NOAA FORM 76-35A	
U.S. DEPARTMENT OF COMMERCE NATIONAL OCEANIC AND ATMOSPHERIC ADMINISTRATION NATIONAL OCEAN SERVICE	
DESCRIPTIVE REPORT	
Type of Survey .....	Hydrographic
Field No. ....	RA-20-3-97
Registry No. ....	H-10701A
LOCALITY	
State .....	Alaska
General Locality .....	Southwest Alaska Peninsula
Sublocality .....	Chignik Bay
.....	
1997	
CHIEF OF PARTY CAPT Alan D. Anderson, NOAA	
LIBRARY & ARCHIVES	
DATE .....	NOV 24 1998

# Descriptive Report to Accompany Hydrographic Survey H-10701A

## **EVALUATION REPORT**

ATTACHMENT 3  
H-10701a LIMITS DEPICTED ON CHART 16566,  
9th EDITION March 7, 1998.  
LIMIT LINE DENOTES AREA OF SUPPLEMENTAL  
COVERAGE COMMON TO H-10701.  
[Hatched Box] SUPERSEDED AREA OF CHART  
NOT TO SCALE (3 of 3)

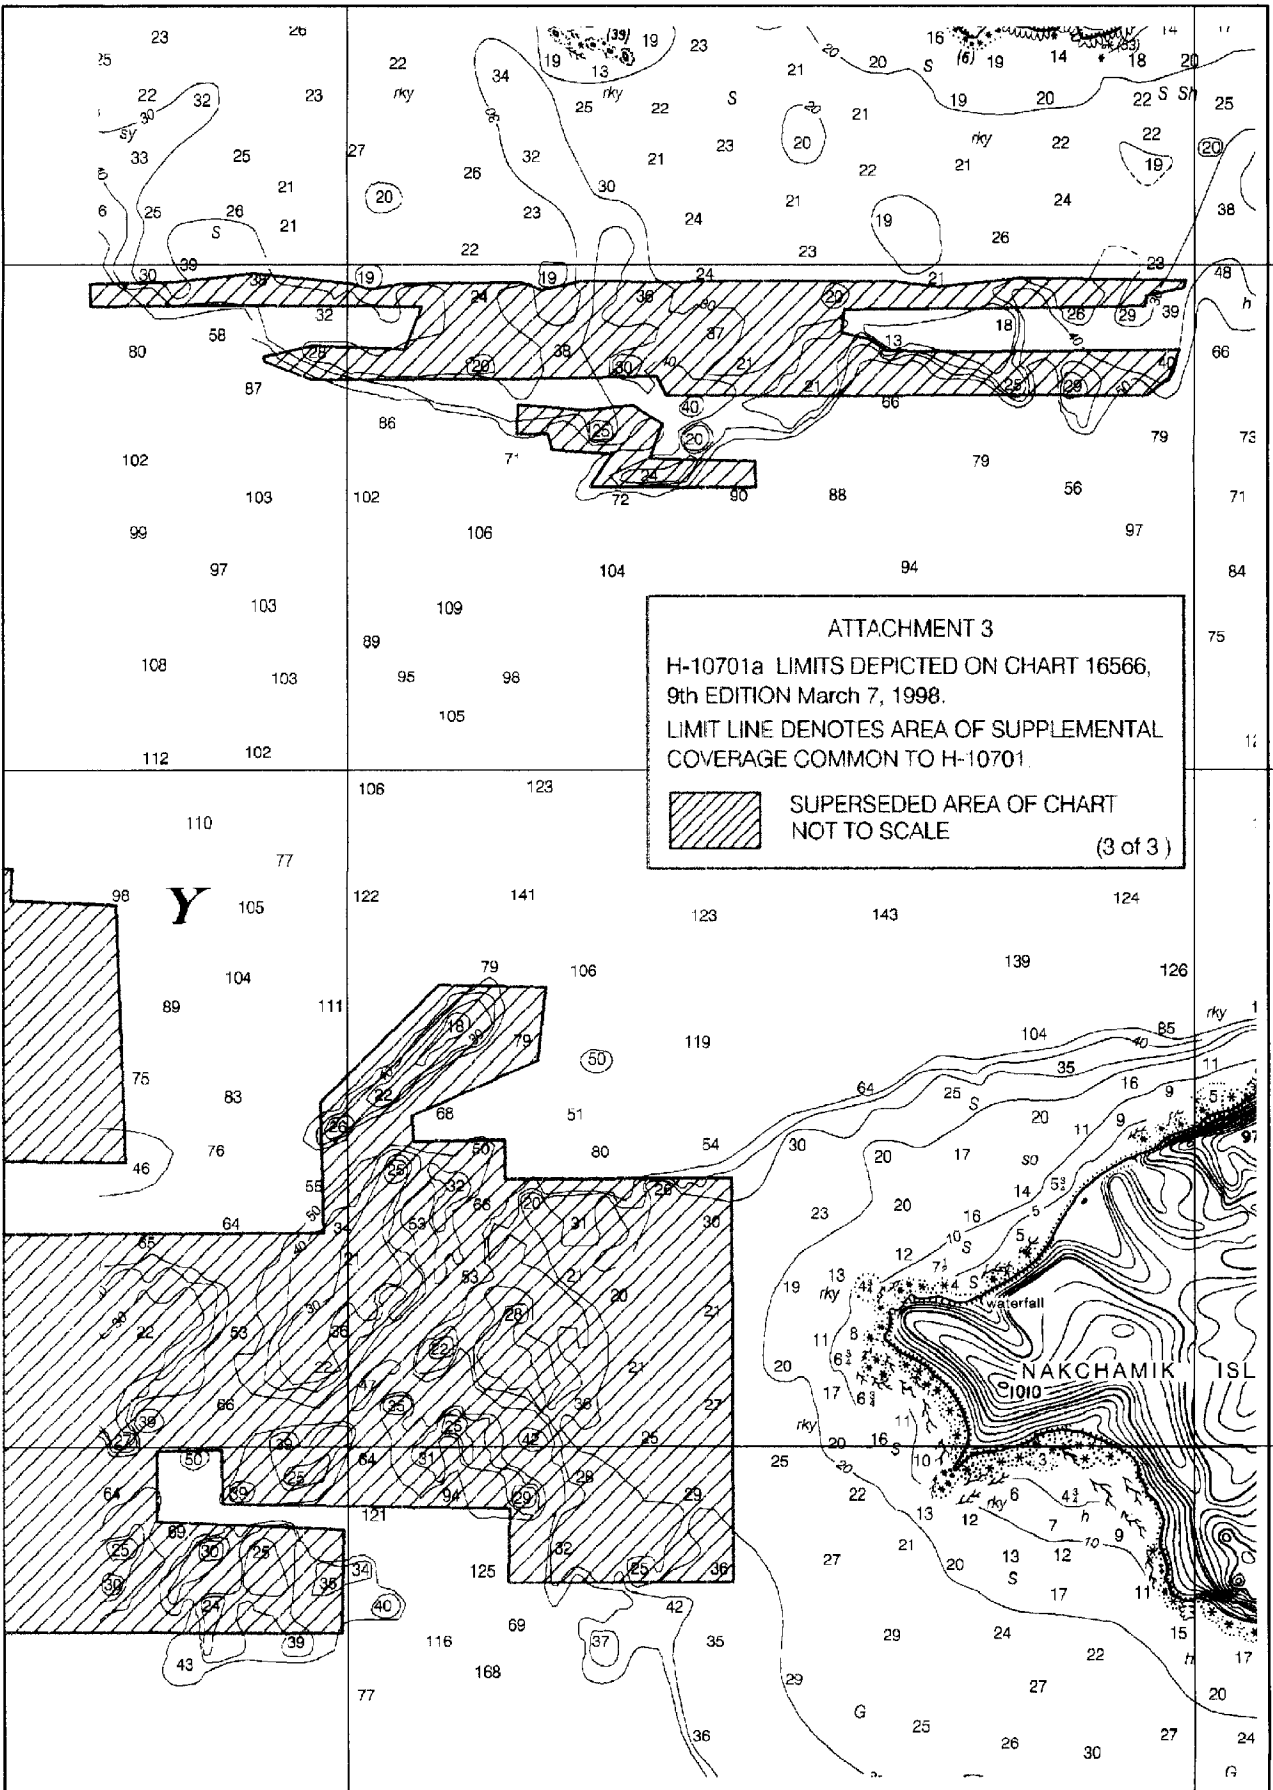
The present survey, considered to be supplemental to survey H-10701, overlaps most of the earlier survey area. Both surveys were temporarily digitally merged and from that combined product depth curves were drawn throughout the present survey area to provide a more accurate and detailed depiction of the bottom. Depths required to support the present survey depth curves were transferred to the smoothsheet from survey H-10701. However, because standard depth curves could not be brought into coincidence due to the significant differences in data density between the two surveys, an "Adjoins" note has been added to the smooth sheet where applicable.

Chart 16566, 9th Edition comprises data from H-10701 (1996) and two retained prior soundings (25fm/57fm) from H-4449 (19924). The prior soundings above been adequately addressed in the evaluation report, section M. The compilation of the 10<sup>th</sup> Edition reflects retaining the shoaler compiled soundings from H-10701 supplemented by newly found shoal depths from H-10701a. In addition, similar depths from H-10701a have been used to replace those soundings from H-10701 currently shown on chart 16566. Charted depth curves have been revised to reflect both surveys within the common area.

The two charted prior depths should be removed from the chart. Chart this area based on the present survey.
